Departure from Sign Design Standards Collingbrook at Rodenhauser

DSDS-696

STAFF REPORT

SUBJECT: Departure from Sign Design Standards DSDS-696
Collingbrook at Rodenhauser

SITE PLAN WITH SIGN LOCATION OUTLINED IN GREEN

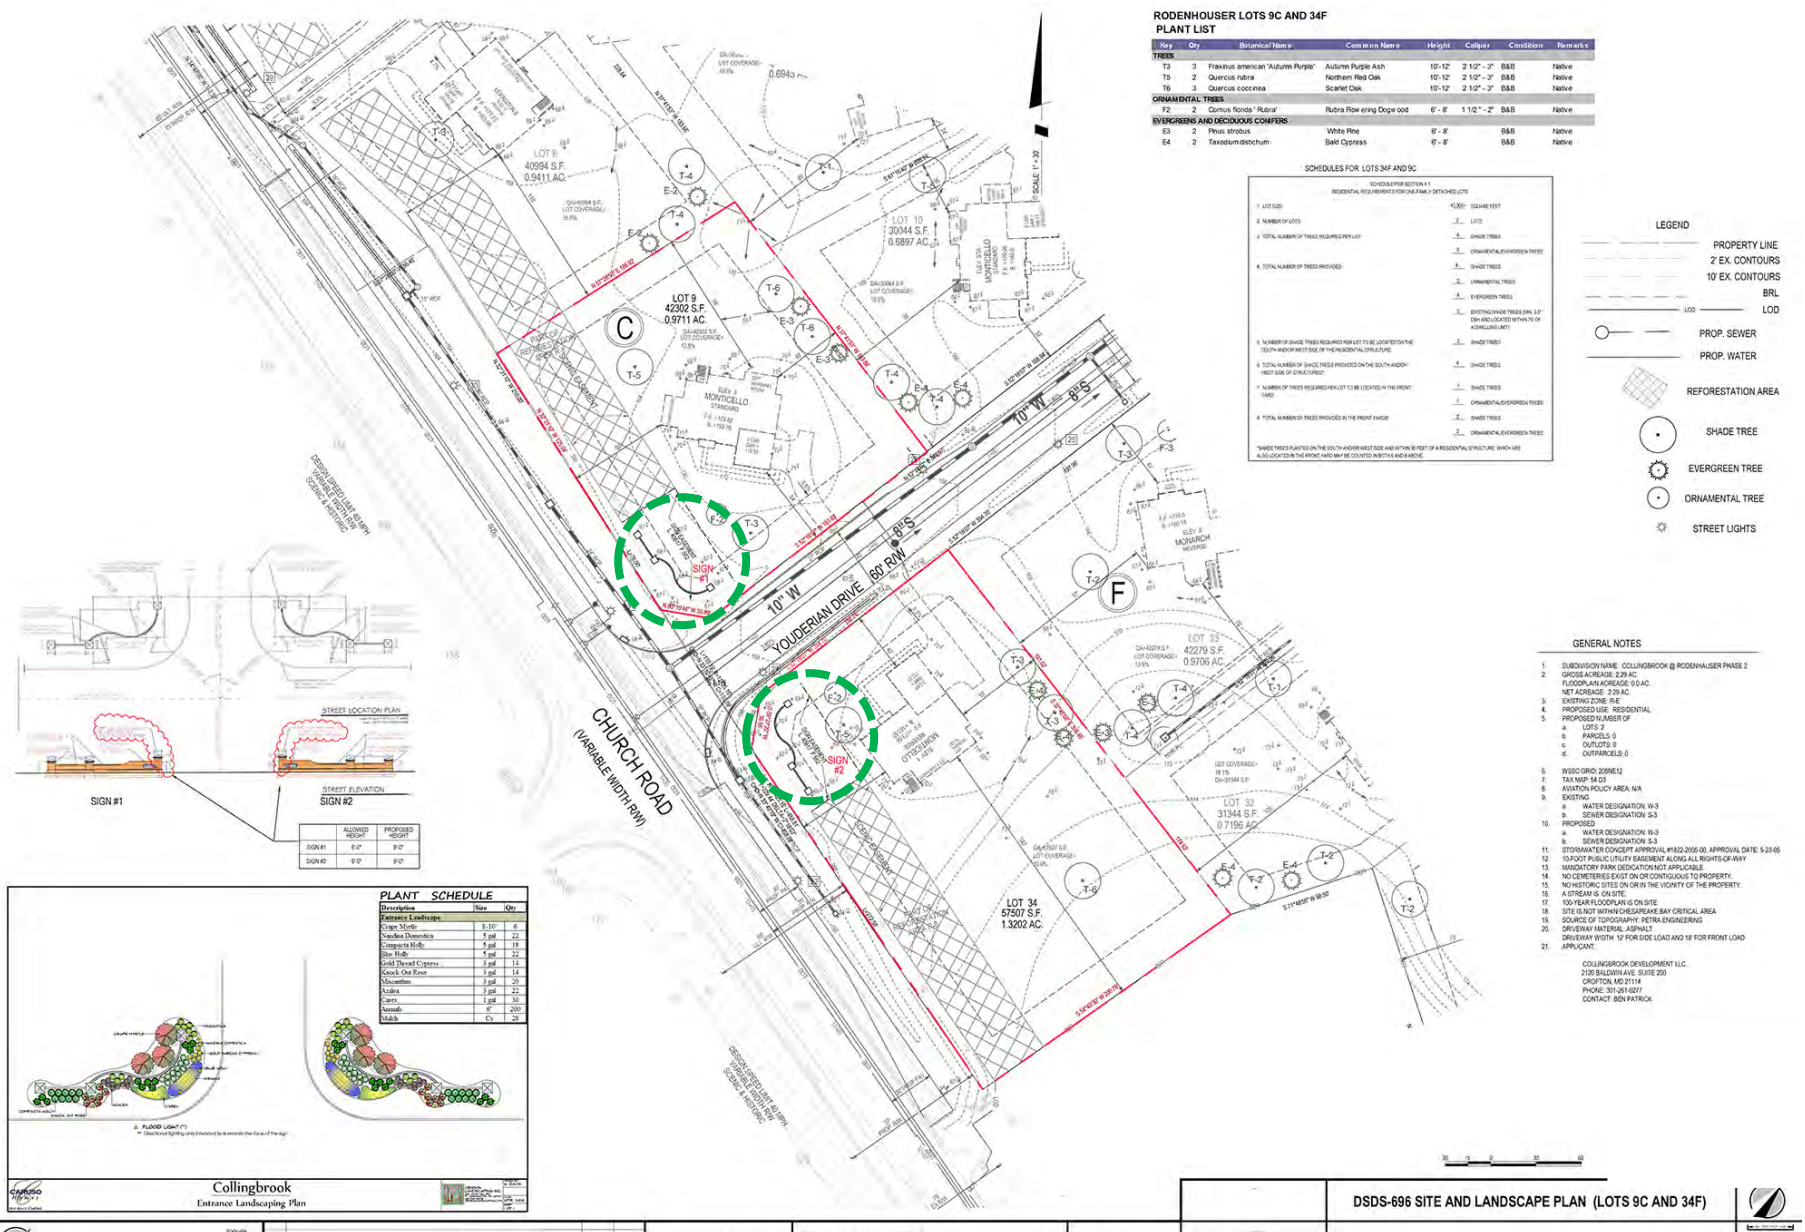
- d. Add native, 3.5- to 4-inch-caliper, shade trees, to the maximum extent possible, behind the signs, extending to the remaining width of the 40-foot scenic and historic buffer and reforestation areas, and provide native shrubs in front of the signs on the site and landscape plan.

- h. Add the site's property lines to the landscape detail and ensure that the plantings are located within the site's boundary.
2. Prior to certification of the departure site plan, the recorded sign easement agreement shall be amended to extend the easement to the right-of-way, to allow access to the sign area, and recorded. The departure site plan shall reflect the extended easement location and the new recordation reference.

1. The actual signage is placed outside of all dedicated rights-of-way. It is noted, however, that landscaping associated with the gateway signage appears to extend within the dedicated rights-of-way at the Church Road/Youderian Drive intersection (this is not clear because the landscape plans do not show property lines). The applicant shall be aware that any landscaping placed within the public right-of-way is subject to permitting by the County and may involve a separate maintenance agreement with the County prior to permitting.

GATEWAY SIGN DETAILS

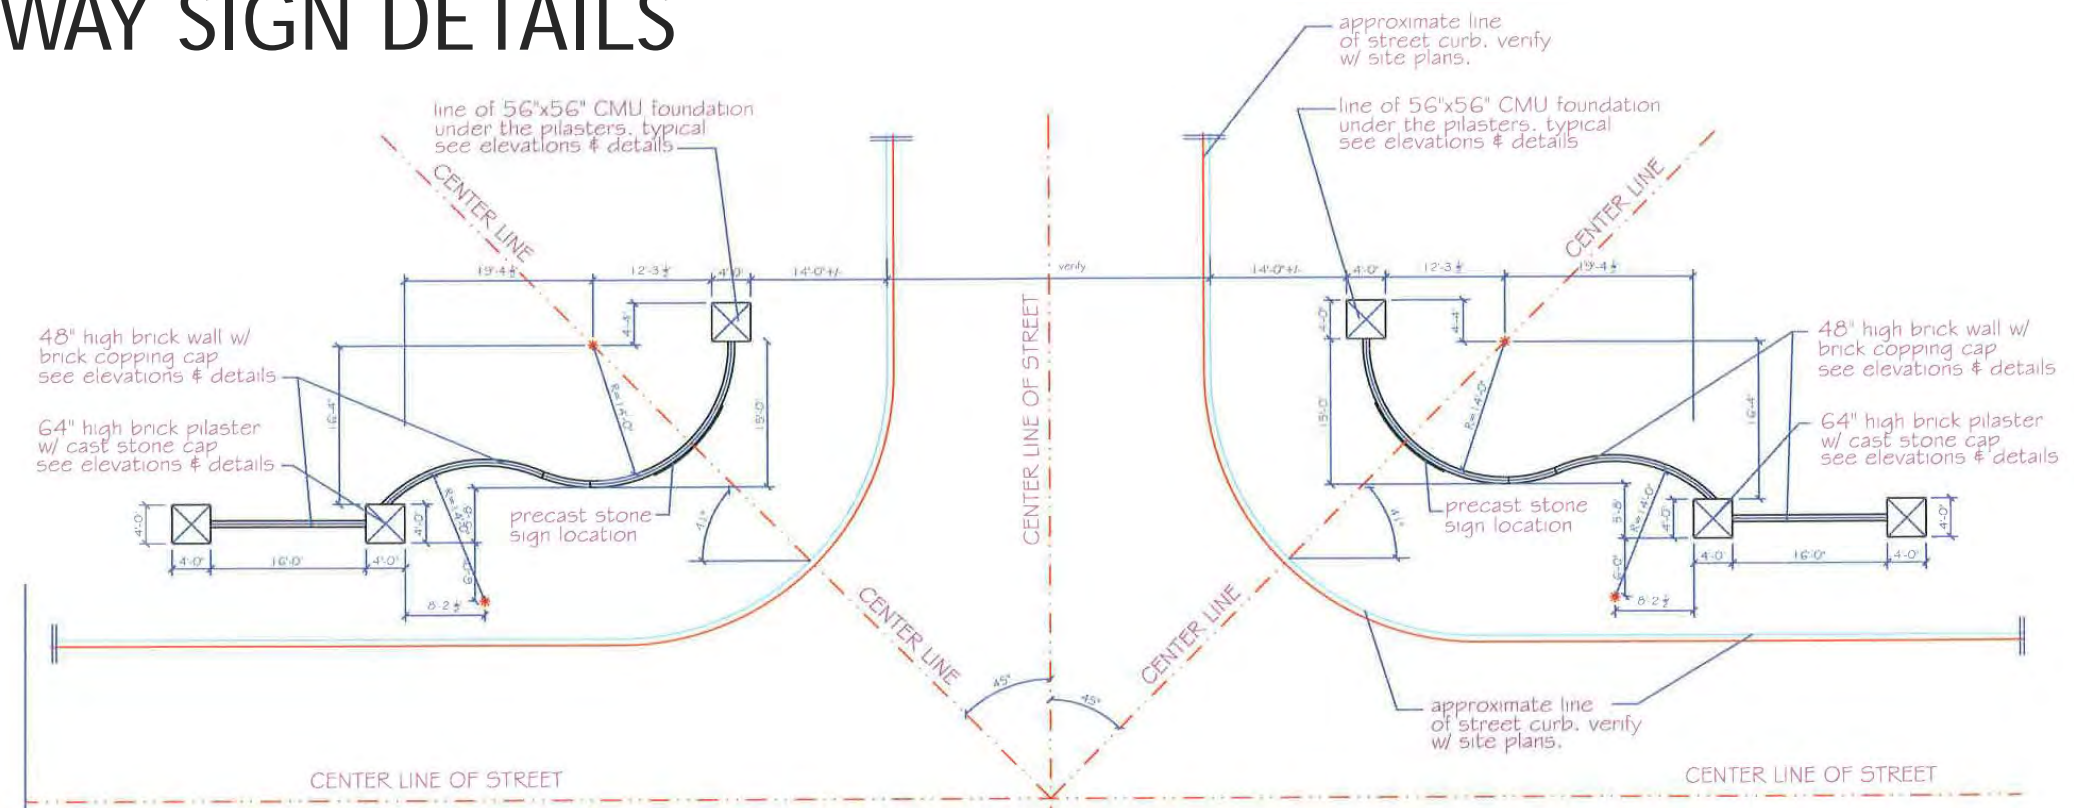
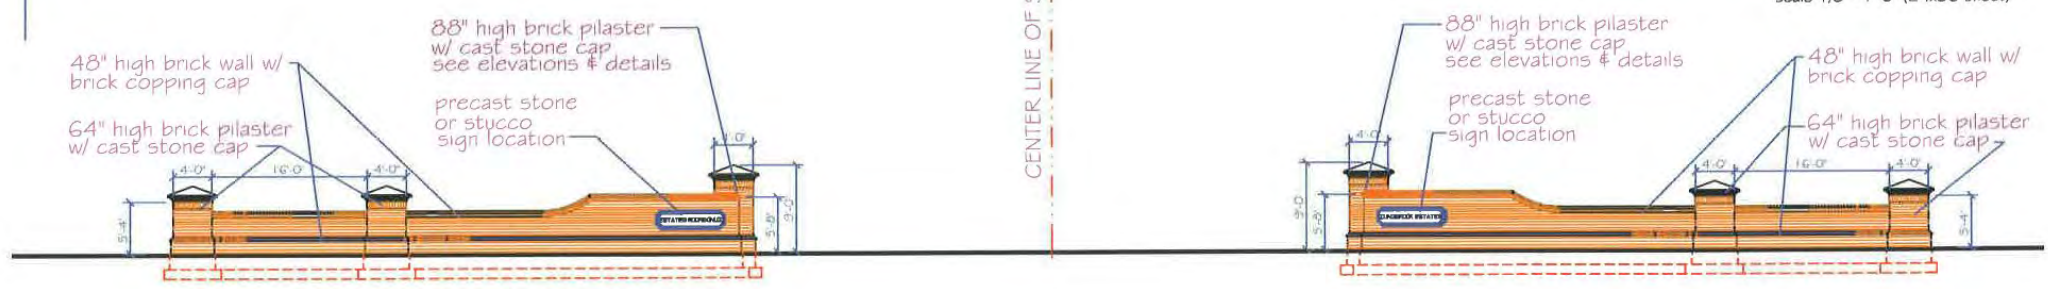
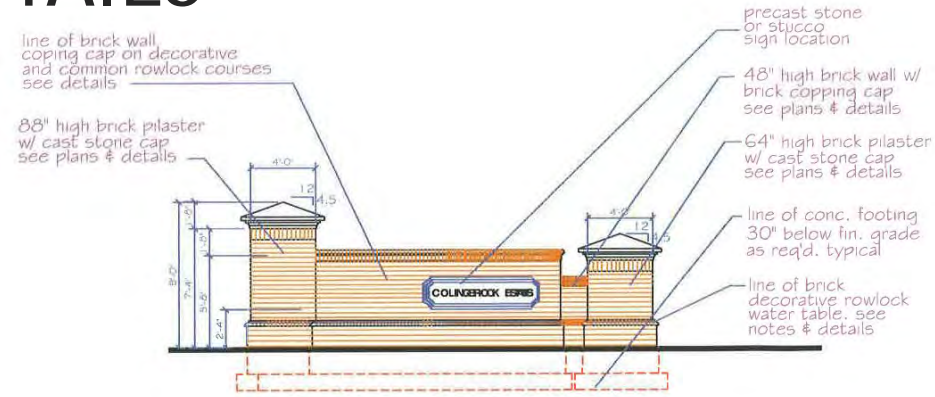
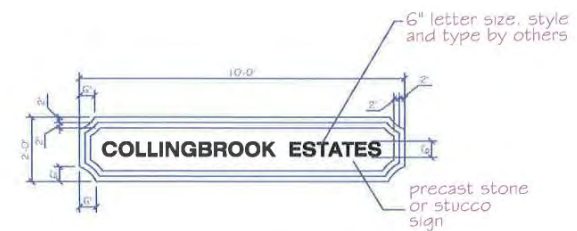
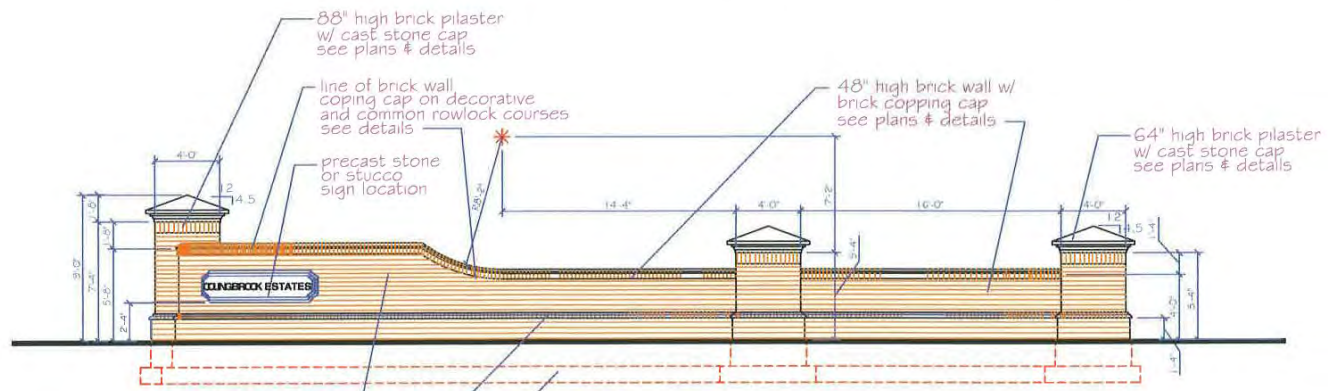
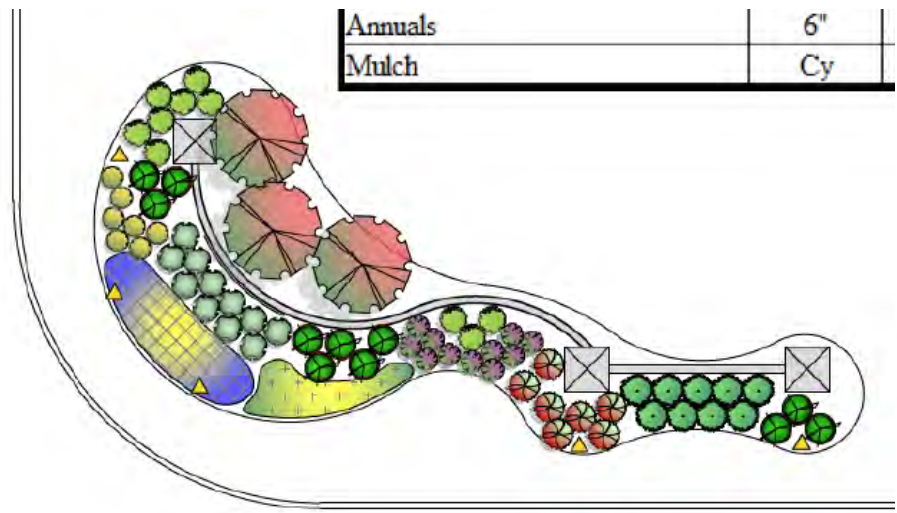
The applicant is requesting a DSDS for the area requirements because the gateway sign exceeds these parameters. The submitted sign details show that the lettering area on the proposed gateway signs is limited to approximately 19 square feet, where the name of the community, "Collingbrook Estates," is incised into precast masonry sign face. A departure of seven square feet of lettering area is requested.

- b. Indicate the maximum height of the sign only, versus the height of the entrance feature, on the site and landscape plan.
 - c. Indicate the standard sign lettering area required, per the Prince George's County Zoning Ordinance, and the sign lettering area approved with this application.

- e. Indicate that the site is within Aviation Policy Area 6 in the general notes.
 - f. Remove the M-NCPPC approval block from the plan.
 - g. Provide dimensions from the sign and entrance feature to the right-of-way on the site and sign detail plans.

Exhibit B - Drawing of Sign Easement Areas

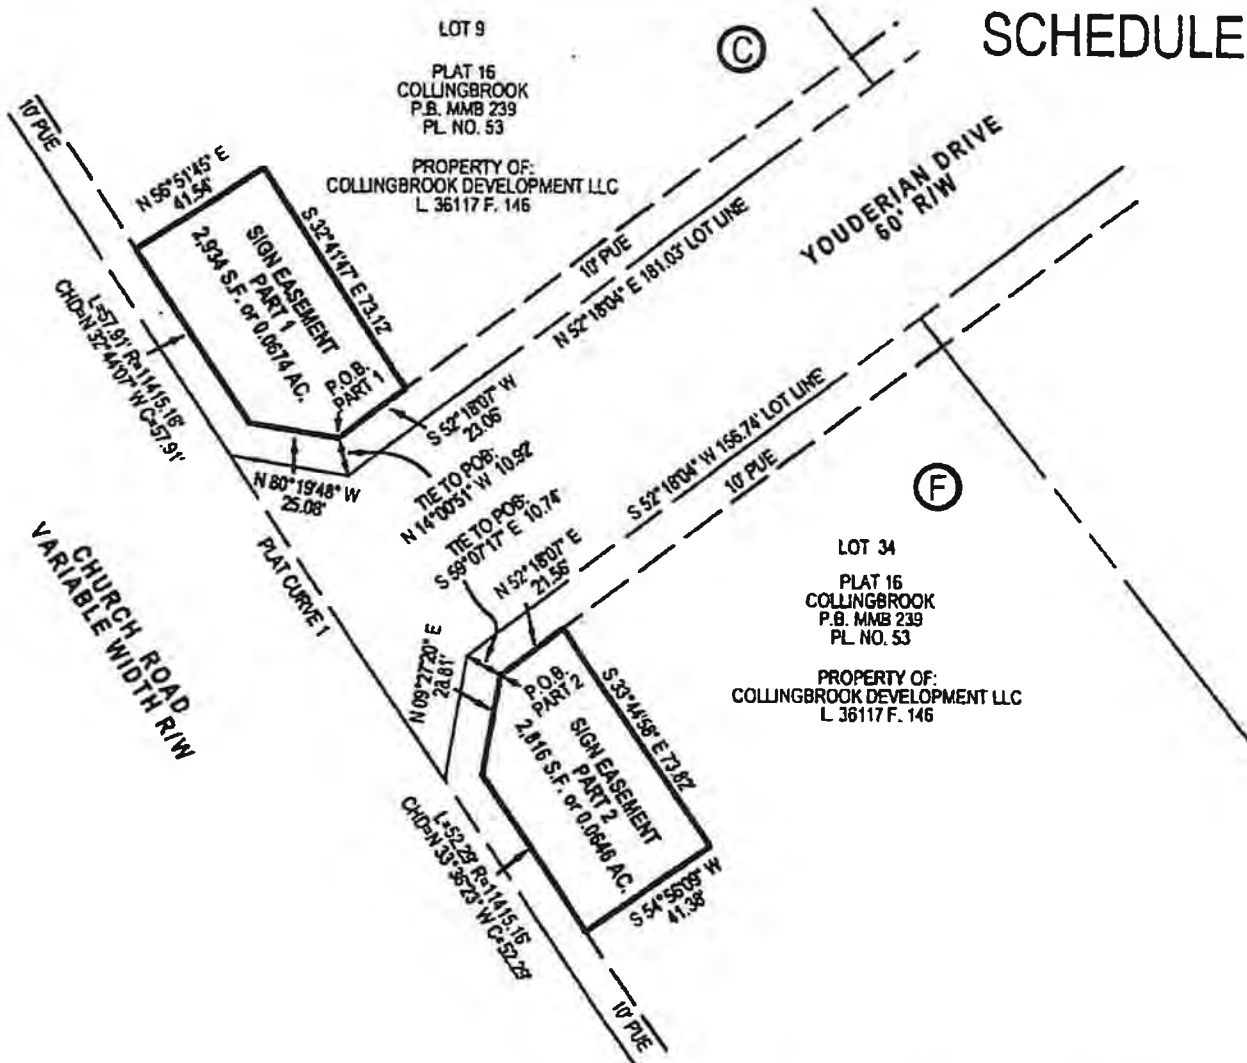
The developer has established a sign easement recorded in Liber 40817 at folio 562, to the benefit of the Collingbrook Estates Homeowners Association, to ensure the maintenance of the signs. However, the sign easement does not extend to the right-of-way and should, in order to allow access to the sign easement area. Staff recommends that the easement agreement be amended, and the site plan revised to show an extended easement, which provides access to the signs.
